Certificate of Appropriateness

2823-25 N. Sherman Blvd. Sherman Boulevard HD

9/24/2019 PTS ID 114861 COA new roof

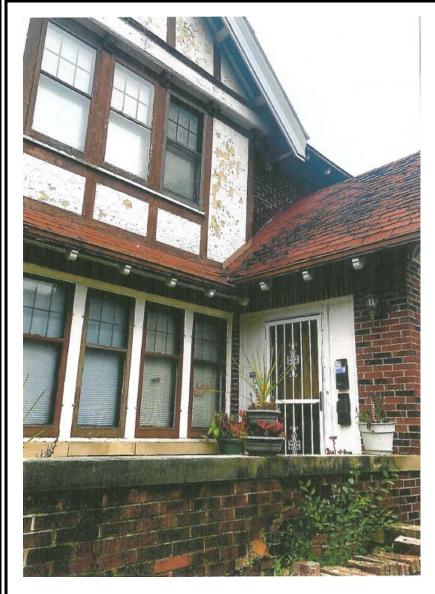
New mortar for the chimney must match the original mortar in terms of color, texture, grain size, joint width, and joint finish/profile. **Use** mortar as close as possible in color to **US Heritage Group SC Sahara (2).** The compressive strength of the repointing mortar shall be equal or less than the compressive strength of the original mortar and surrounding brick or stone. The replacement mortar shall contain approximately the same ingredient proportions of the original mortar. Mortar that is too hard is subject to premature failure and could damage the masonry. See the city's books As Good As New or Good for Business, Masonry Chapters, for more information. In most cases, this means a lime mortar with natural hydraulic cement rather than Portland cement. No joint of a width less than 3/8" may be cleaned of damaged/decomposed mortar with power disc grinders. No over-cutting of the joints is permitted. Remove decomposed mortar

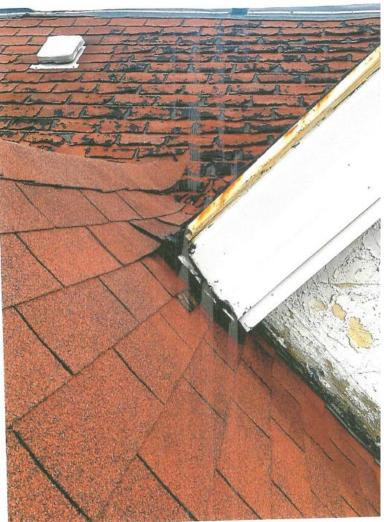
New Atlas Castlebrook shingles to be installed, Burnt Sienna

Gutters to be aluminum seamless

Chimney to be step flashed and repointed with appropriate mortar, as close as possible to US Heritage Group color SC Sahara (2)

Valleys **must** be metal, **NO** interweaving of shingles (as is shown above is present condition)

Chimney to be step flashed (as is shown in the present condition above) and repointed with appropriate mortar, as close as possible to **US Heritage Group color SC Sahara (2)**

Atlas Castlebrook shingles in Burnt Sienna to be utilized
